APPLICATION NO.	FILING DATE	FIRST NAMED INVENTOR	ATTORNEY DOCKET NO.	CONFIRMATION NO.
10/820,012	04/08/2004	Thomas J. Fox	JHM1335	8556

Office Action Summary	Application No.	Applicant(s)	
	10/820,012	FOX, THOMAS J.	
	Examiner	Art Unit	
	Jon A Szumny	3632

This is the first office action for application number 10/820,012, Leaf Bagger, filed on April 8, 2004.

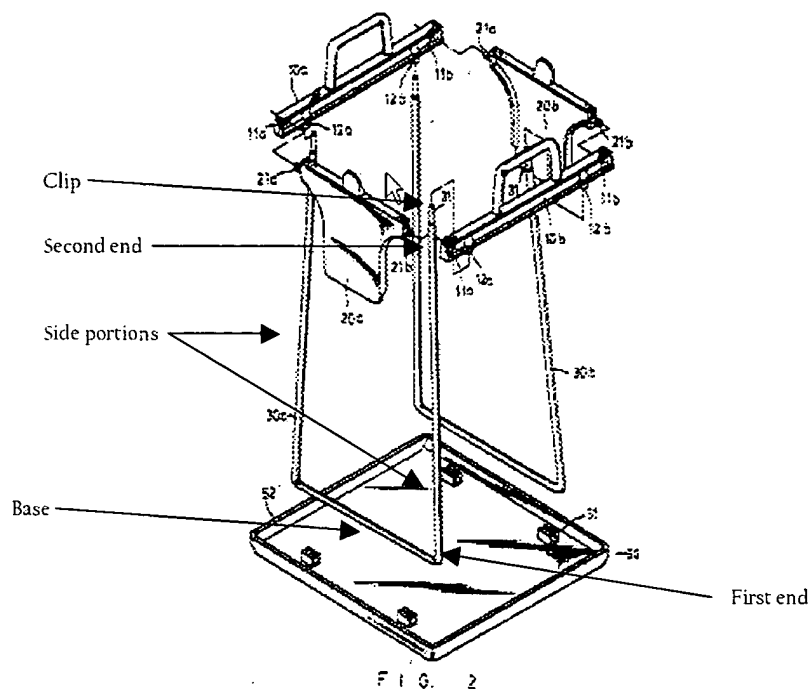
Claims 1, 6, 8, 10, 14 and 16 are rejected under 35 U.S.C. 102(b) as being anticipated by U.S. Patent number 4,188,005 to Lee.

Lee '005 discloses a support frame (figure 1) comprising first and second side frames (14c,14b), pivot/hinge means (near 21), holding/fixing means comprising a triangular ring (13a-13c), and securing/retainer/retaining means (43), wherein the triangular ring has a plurality of offsets (31,38a-38c, an "offset" is defined in Merriam Webster's Collegiate Dictionary - 10th Edition as being "a displacement or abrupt change in dimension or profile of an object", so clearly, at the region of the holes 31,38a-38c, there is an offset positioned on the ring), wherein each side frame has a base (bottom of 32), a first side (left side of frame) connected to one side of the base and a second side (right side of frame) connected to another side of the base.

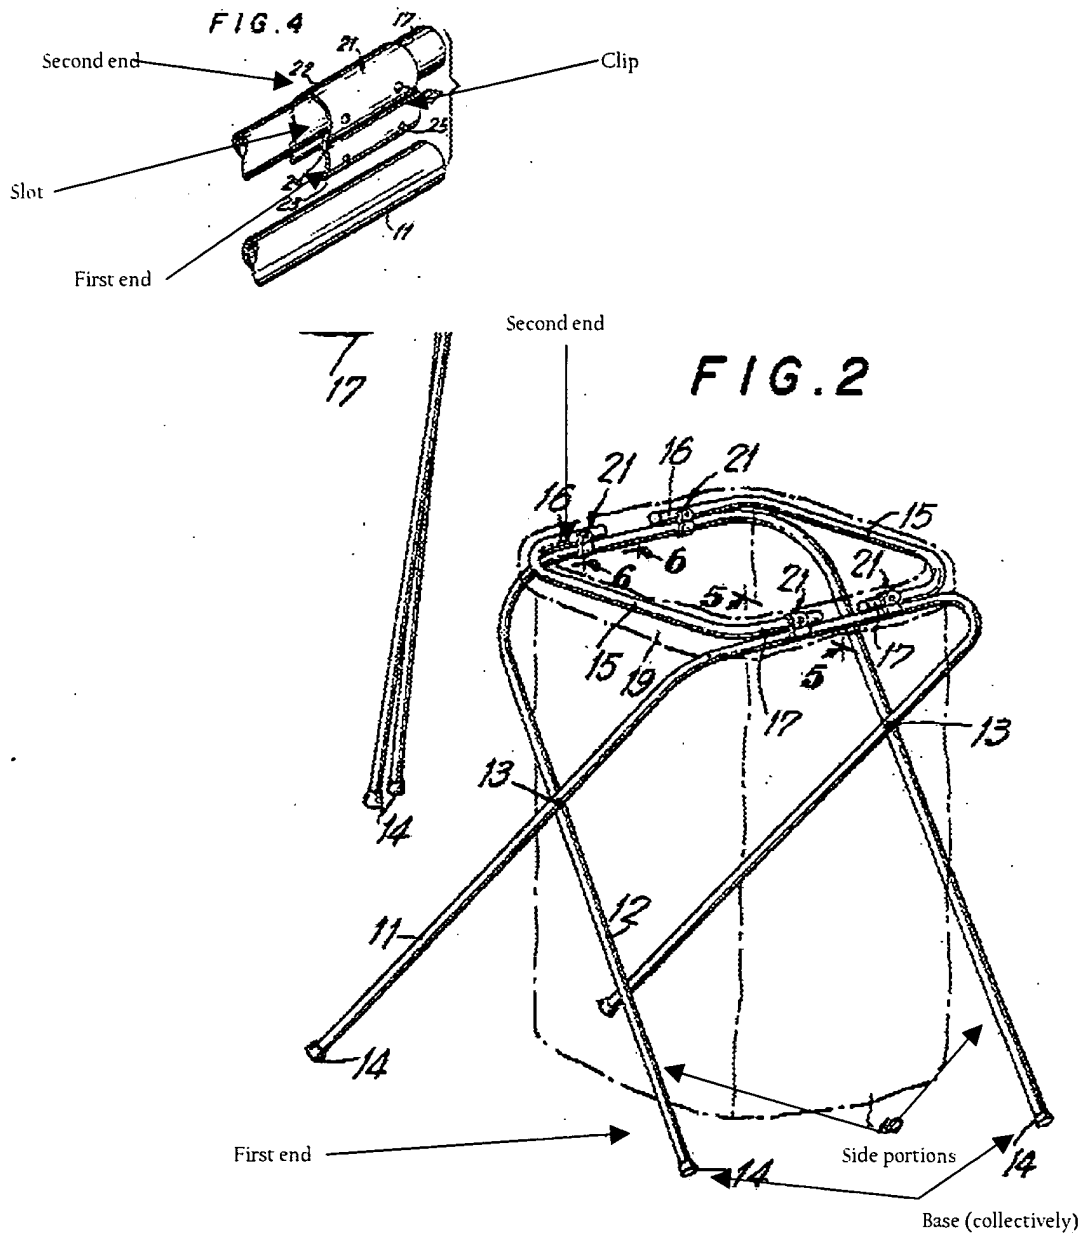
Claims 11 and 12 are rejected under 35 U.S.C. 103(a) as being unpatentable over He '672 in view of U.S. Patent number 3,502,291 to Ackerman et al.

Regarding claim 11, He '672 teaches the previous invention failing to specifically teach the first and second sides of each frame to be hollow. Nevertheless, Ackerman et al '291 divulges a support frame (figure 2) with first and second side frames each including first and second hollow sides (figure 5). It would have been obvious to one of ordinary skill in the art at the time the invention was made to have modified the first and second sides of each side frame of He '672 so as to be hollow as in Ackerman et al. '291 so as to provide for a more lightweight device. Further, with respect to claim 12, He '672 teaches a plurality of clips (above, they are clips because a clip is defined in Merriam Webster's Collegiate Dictionary - 10th Edition as "any of various devices that grip" and clearly these "grip", see column 2, lines 48-49, "frictionally") inserted into hollow members 12a,12b, but fails to specifically teach vice versa wherein the clips are inserted into hollow first and second sides of each frame. It would have been obvious to one of ordinary skill in the art at the time the invention was made to have reversed the parts so that the clips are inserted into hollow first and second sides of each frame since a reversal of parts is held to be an obvious expedient. See *In re Gazda*, 219 F.2d 449, 104 USPQ 400 (CCPA 1955). Further, after such a reversal, the clips inherently receive and hold the fixing means (although a rigid attachment, the clips do in fact receive and hold the fixing means).
